TECHNICAL BULLETIN

407-11-95
15 December 2011

MODEL AFFECTED: 407

SUBJECT: STARTER-GENERATOR 206-062-200-141,
INTRODUCTION OF

Figure 1. Duct removal

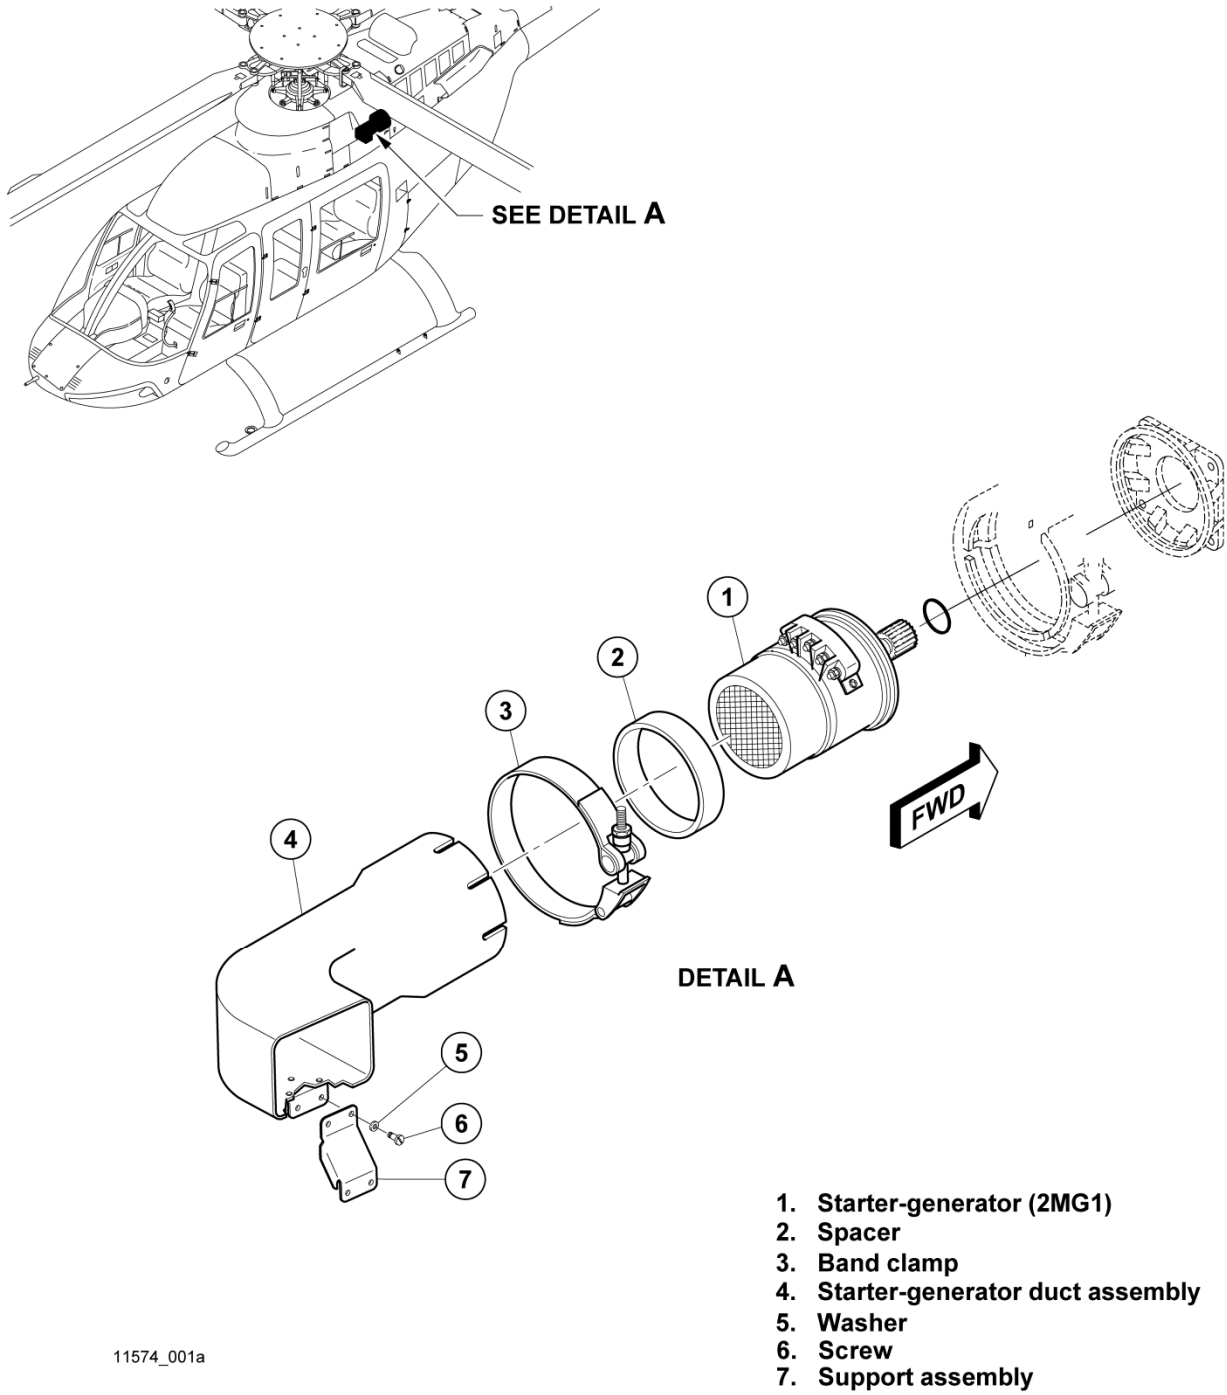
1. Prepare helicopter for maintenance.
2. Gain access to the right side of engine compartment (BHT-407-MM-5 Chapter 53).
3. Remove the starter-generator cooling duct (4, Figure 1) as follows:
 - a. Remove the two screws (6) and the washers (5). Disconnect the duct assembly (4) from the support assembly (7).
 - b. Loosen the band clamp (3). Remove the duct assembly (4) and the spacer (2) along with the band clamp (3) from the starter-generator (1).
4. Mark an index line along the duct to ensure proper alignment is achieved during re-attachment of the duct halves (Figure 2).
5. Rework the starter-generator cooling duct in accordance with Figure 2. Refer to BHT-ALL-SRM Chapter 4 for cutting, surface preparation and wet layup procedures of glass or carbon fiber reinforced composite parts. The wet layup bagging process is optional.

7. Install starter-generator (1, Figure 1), if previously removed, and reworked duct assembly (4) (BHT-407-MM-9 Chapter 71).
8. Make an entry in helicopter historical service records indicating compliance with Part I of this Technical Bulletin.

Figure 2. Duct modification (sheet 1 of 2)

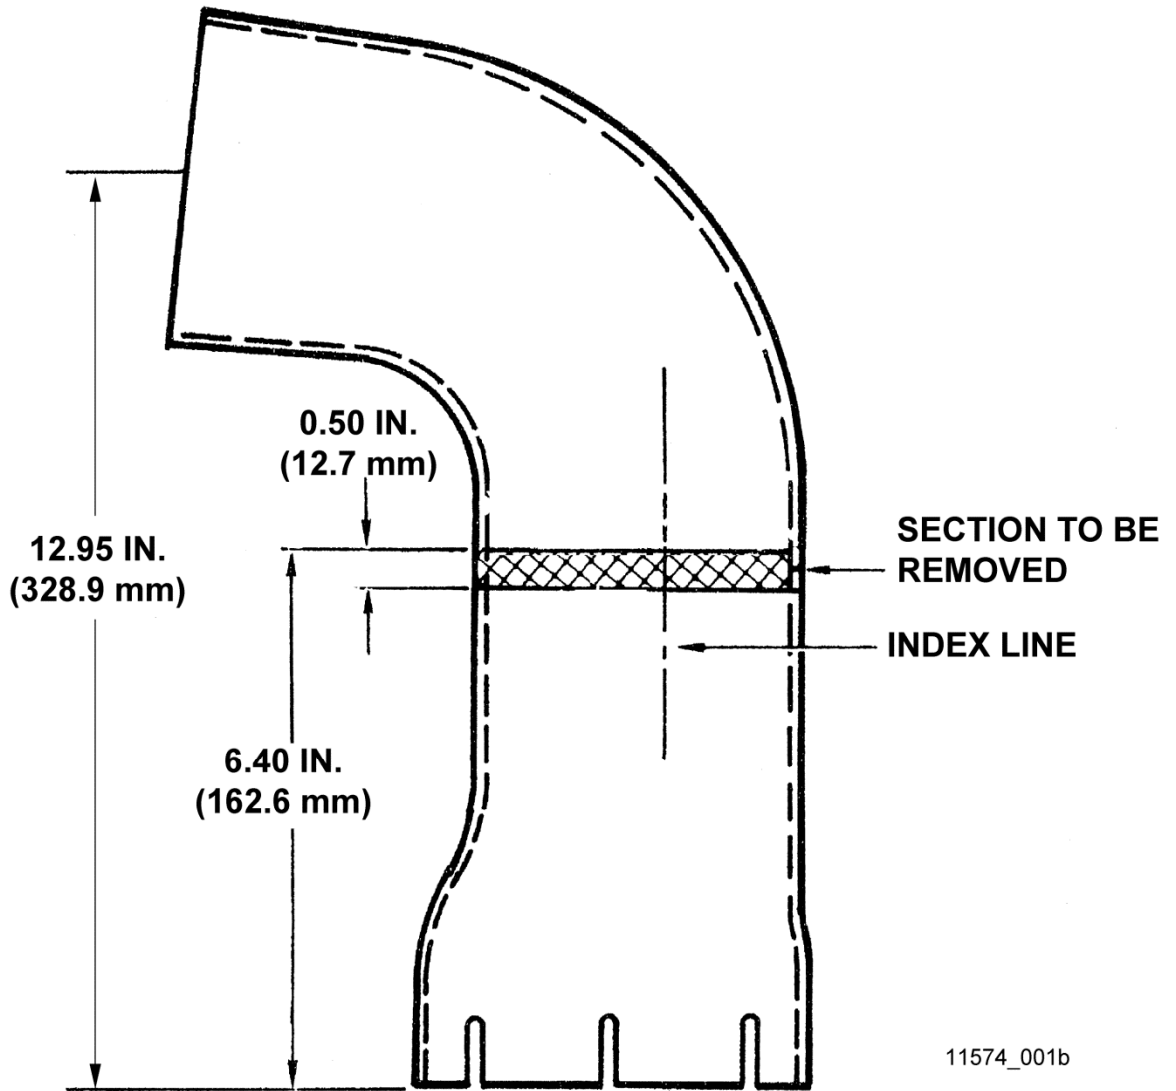
6. Using a permanent ink marker, add the letter "A" at the end of the Bell part number on the cooling duct as follows:

206-064-203-101A
